Keithley Instruments, Inc.
28775 Aurora Road
Cleveland, Ohio 44139-1891
1-888-KEITHLEY
www.keithley.com

Version v1.6.1a Release

Version v1.6.0i Release

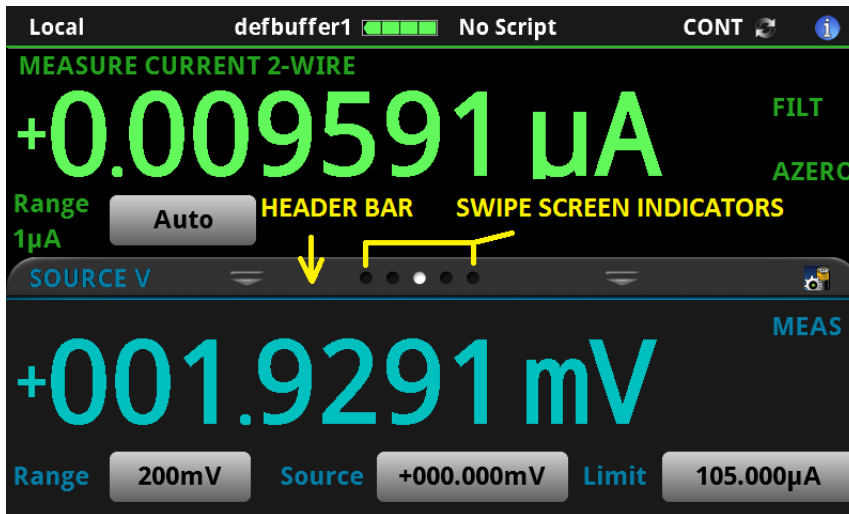
GENERAL Models affected:

A number of improvements have been made to the overall Graphical User Interface as follows:

1. Screen Colors: All screen colors have been modified for better contrast and easier readability.
2. Pinch-to-Zoom Performance: Throughout the user interface, the “Pinch-to-zoom” touch screen motion has been improved and is more responsive.

3. Improve Swiping:
 - a. The swipe user interface gesturing has been dramatically improved and is more responsive.
 - b. Added Vertical Swiping in various screens in the GUI.

- c. Horizontal swiping has been made more smooth and is consistent with Vertical Swiping.
 - d. “Fling” swiping has been implemented where faster swiping actions result in rapid scrolling followed by decay based on the velocity of the “fling.”

- e. Swipe Down on the Home screen will display larger readings.
4. Tabs and Buttons: Throughout the user interface multiple data display options have been made available through tabs (header bars) with swipe screen indicators to show how many different display options are available and which display tab is active.

5. Graphing:
 - a. New Auto Scale Options (X-Axis) → Track Latest, Track Group
 - b. New Auto Scale Options (Y-Axis) → y-swim lanes, y-shared, y-per trace
 - c. Multi-Trace Line Plots
 - d. Multi-Trace Scatter Plots
 - e. Various refresh and performance improvements

6. Histogram:
 - a. New Auto-Scale, Auto-Bin, and Fit
 - b. Smartscale choose best scaling option
 - c. Various refresh and performance improvements
7. TTI Synchronization: All Touch, Test, Invent® Keithley Models including the 2450, 2460, and 7510 have been carefully updated so that they are all consistent in look, feel, and general navigation.
8. Updated Reading Table: Added new reading table features and a new Reading Preview Graph. Please see the Reference Manual for further details.
